MEMORANDUM

RE: Historic District Permit Application, Daniel Boggs: 640 Water Street

REQUEST: The applicant proposes to demolish the existing building at 640 Water Street and construct a new building in its place, along with three on-site parking spaces. The project requires review and approval by the Historic District Commission (HDC) due to the property's location within the Historic District.

DUMPSTER ENCLOSURE - FRONT

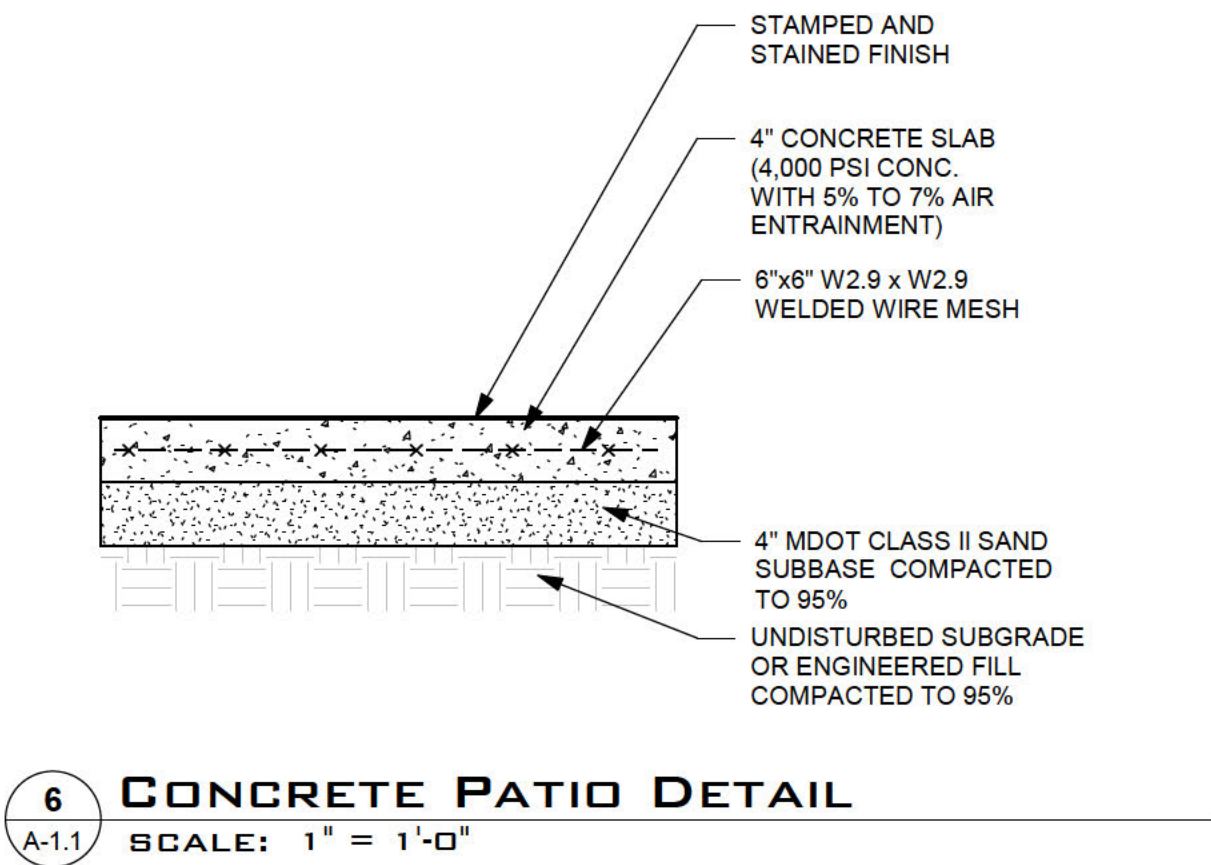
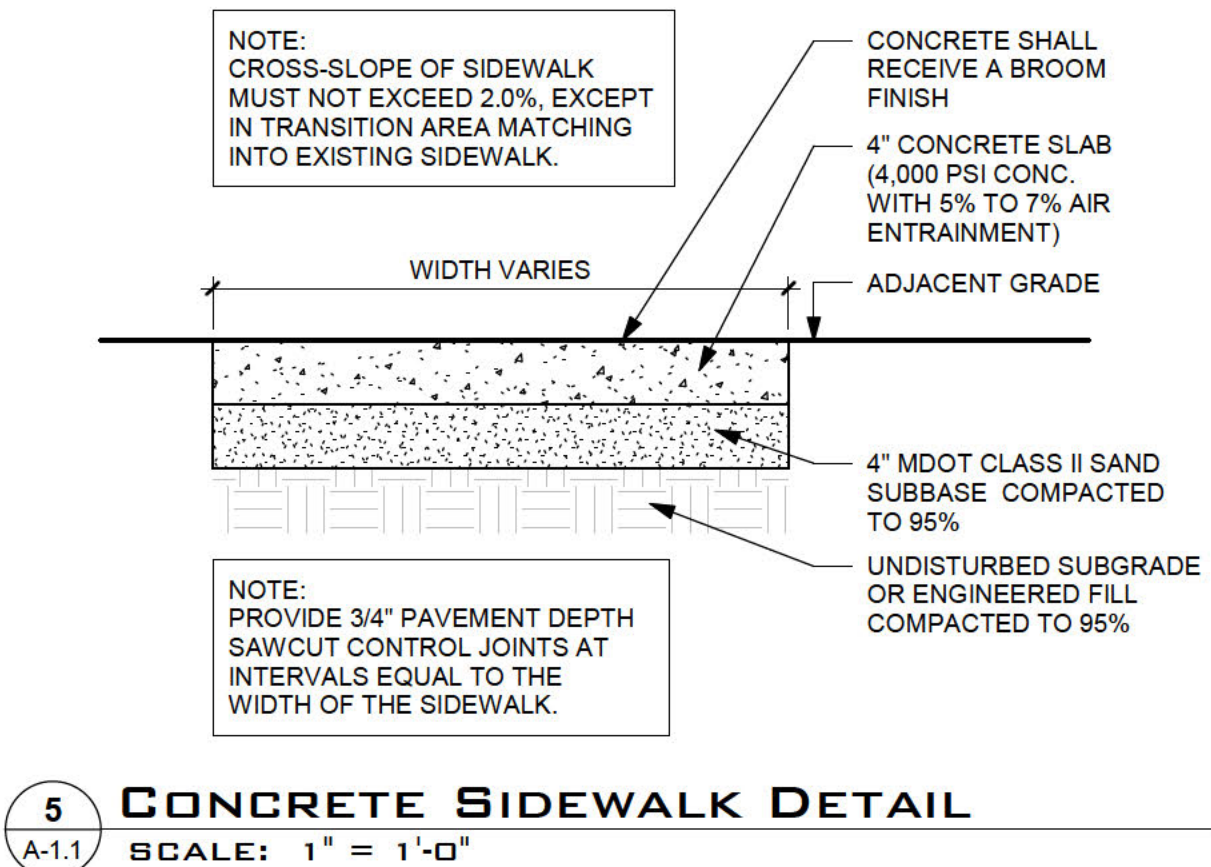
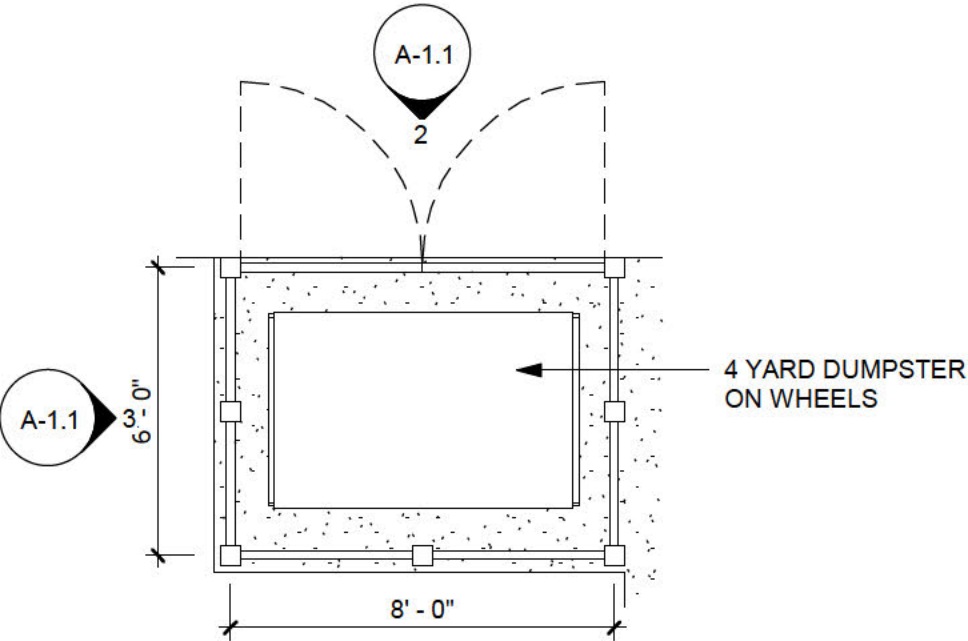
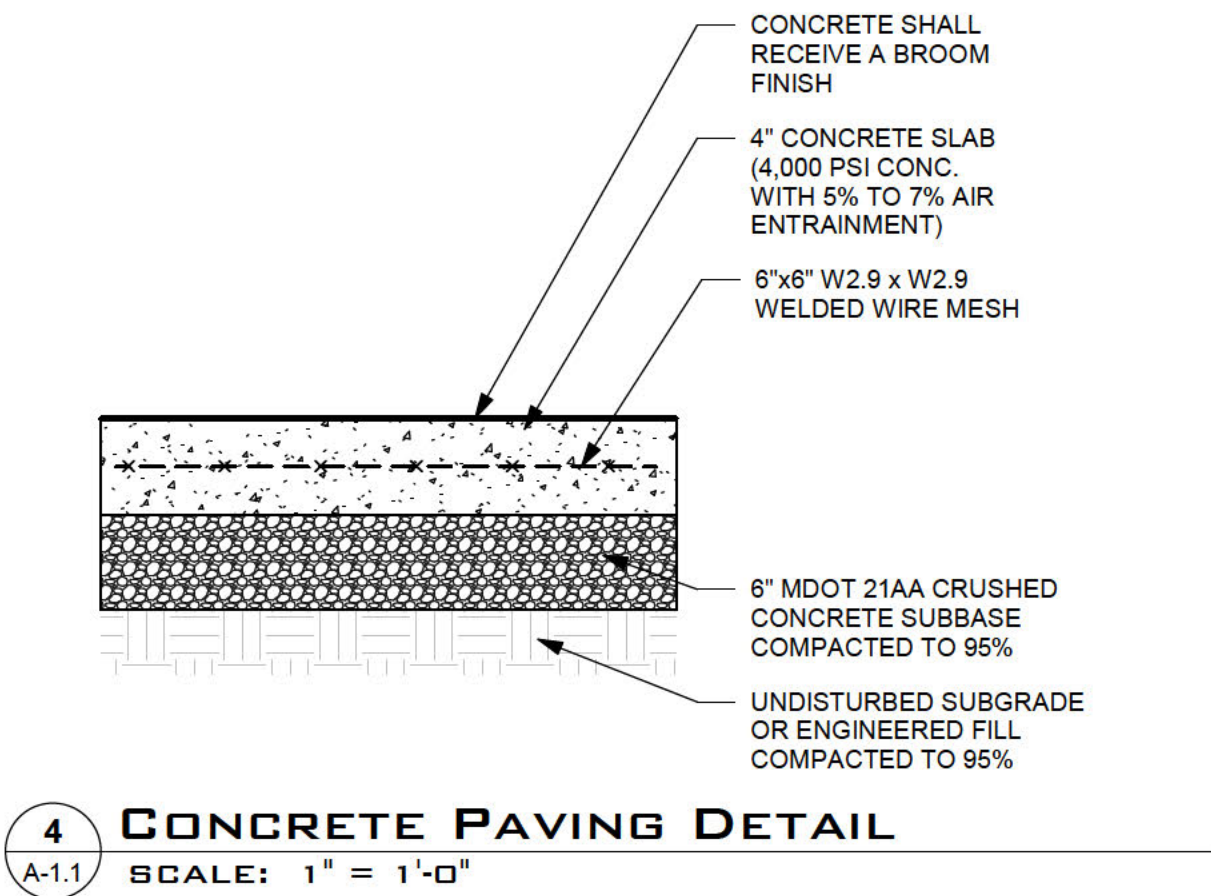
The Planning Commission also recommended a parking lot modification to reduce the setback from 20 feet to five feet along the right-of-way. However, the visual impact of the parking area will be buffered by compliant landscape screening. A screened dumpster pad is proposed behind (west) of the three proposed parking spaces. The dumpster screening materials and final design have not been provided.

1. Final exterior building materials, including siding type and texture, roof material and color, and exterior color selections;
2. Final window and door specifications, including materials, proportions, and glazing;
3. Final details for the dumpster enclosure, including materials, height, and screening design; and
4. Clarification as to whether the proposed waterfront access pathway will impact the previously approved waste receptacle screening at 650 Water Street, with any necessary plan modifications to maintain compliance with prior Historic District Commission approvals.

SHEET TITLE:
Exterior Elevations

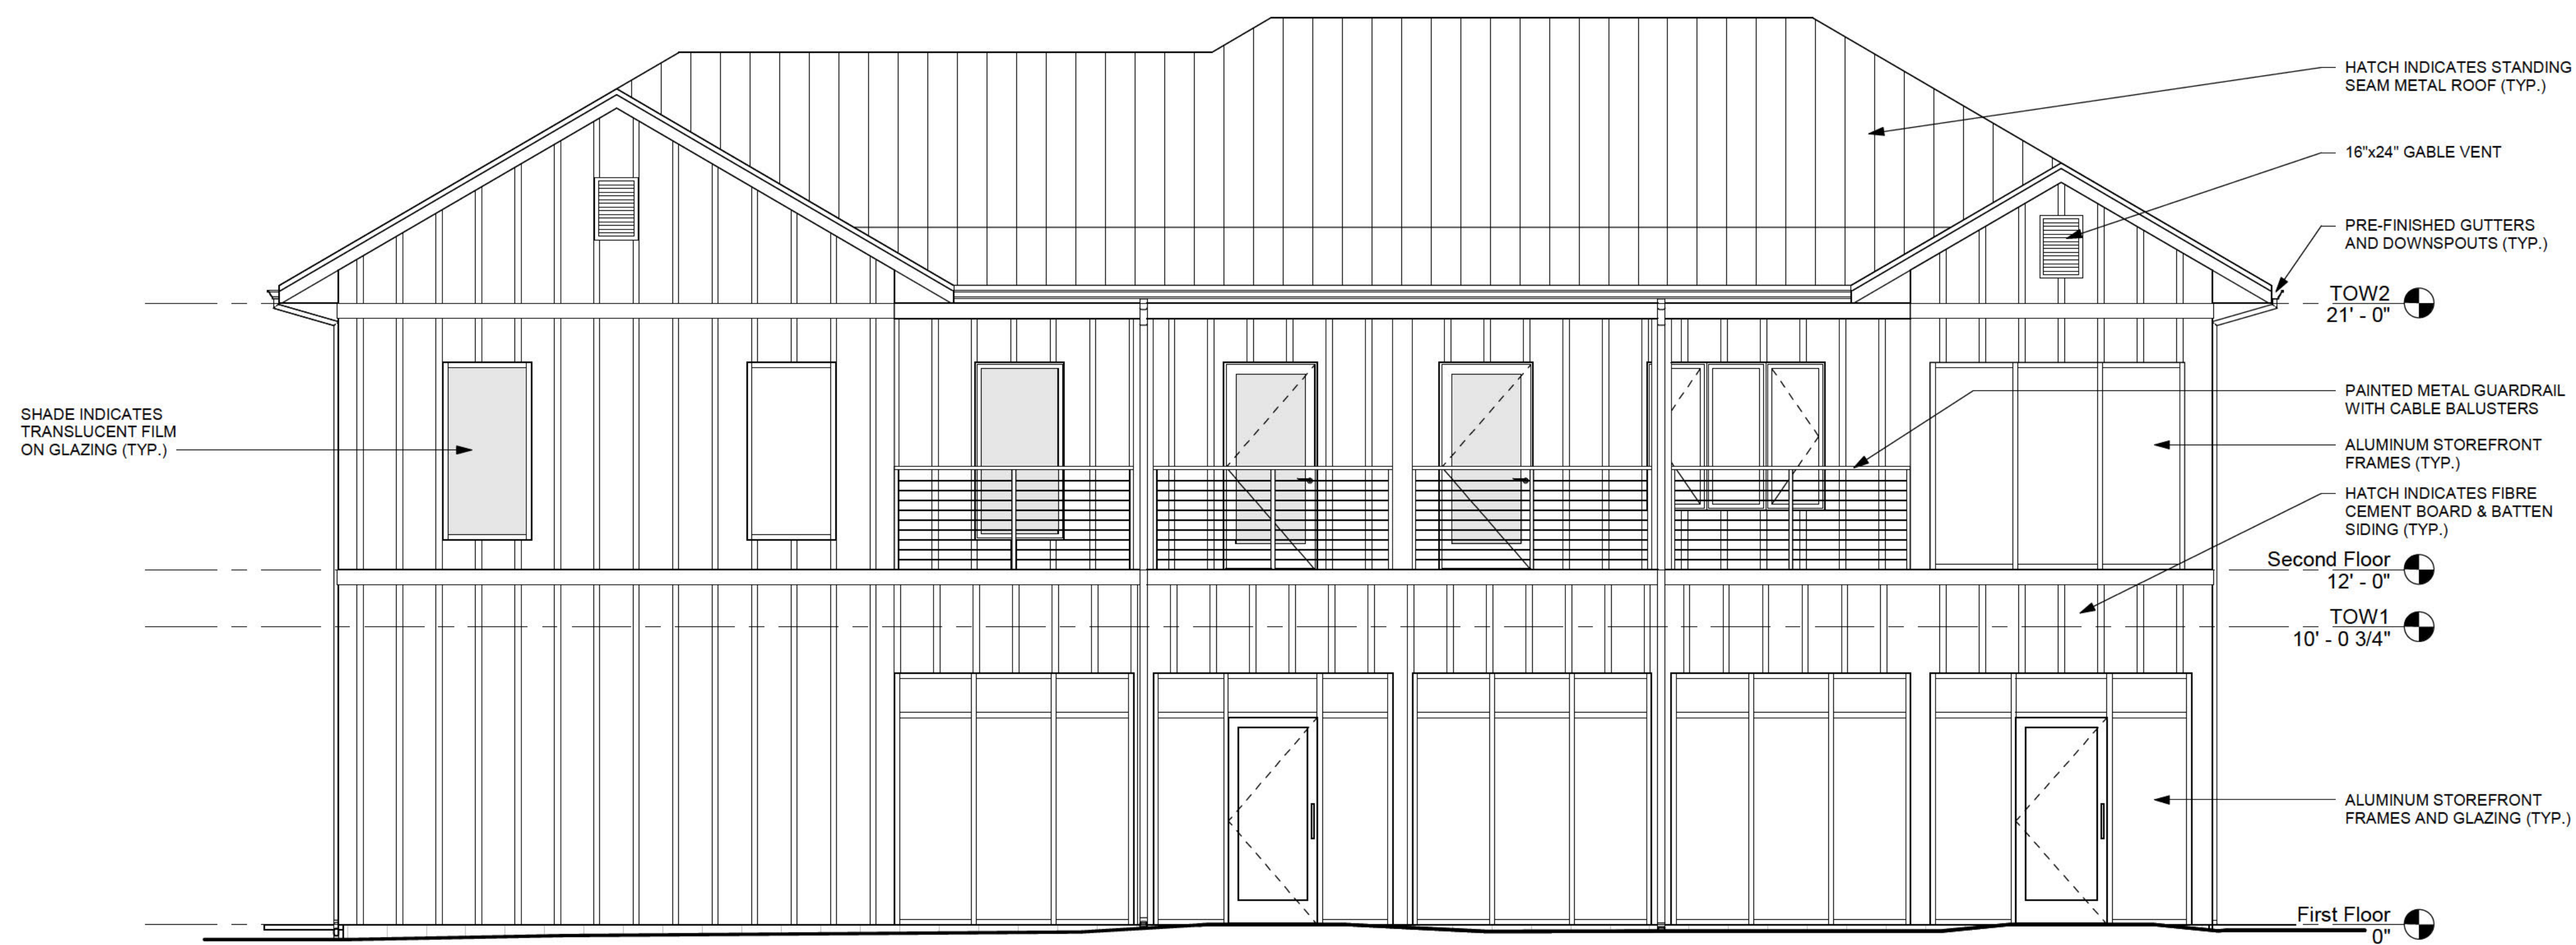
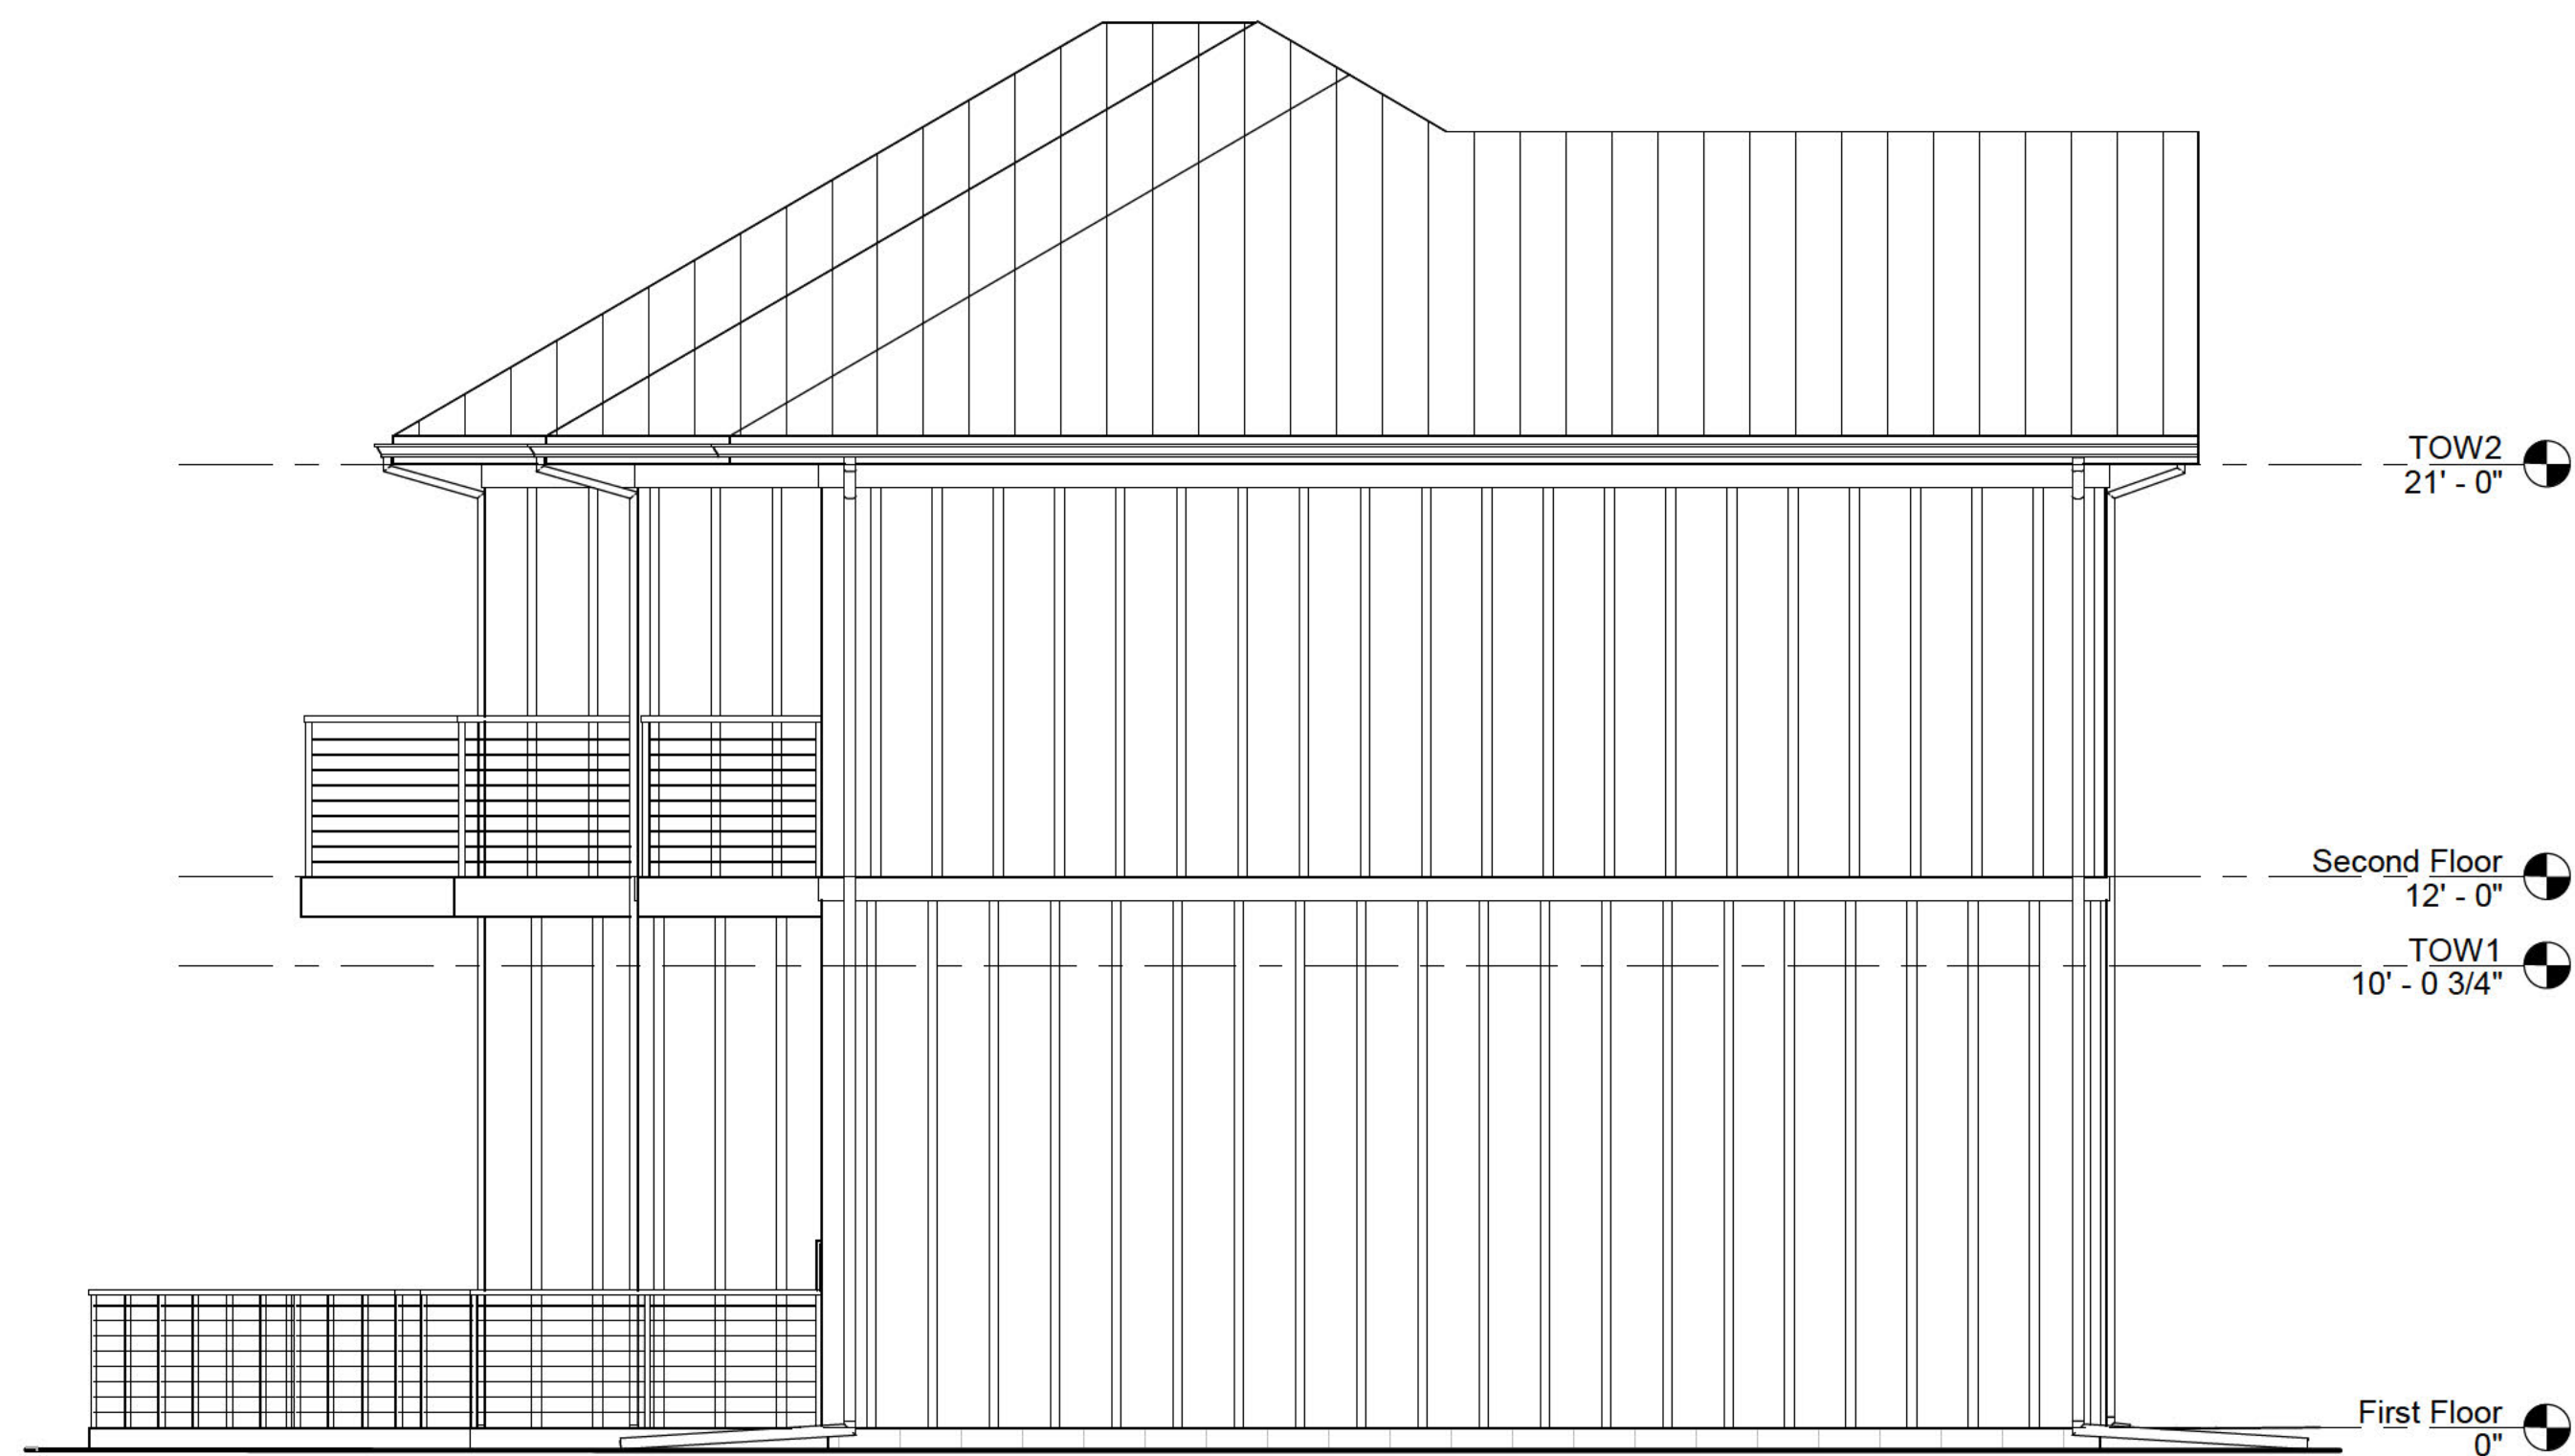
the renderings show a grey first floor and white second floor, it is unknown whether this is the final proposed color scheme, or if the siding is proposed as smooth or textured. The color of the standing-seam metal roof is also unknown. Window and door specifications have not been provided.

Comment: Proposed materials include fiber-cement board-and-batten siding, aluminum storefront glazing, standing-seam metal roofing, and metal balcony railings. Final confirmation of siding texture, roof color, window and door specifications, and exterior color palette has not been provided.
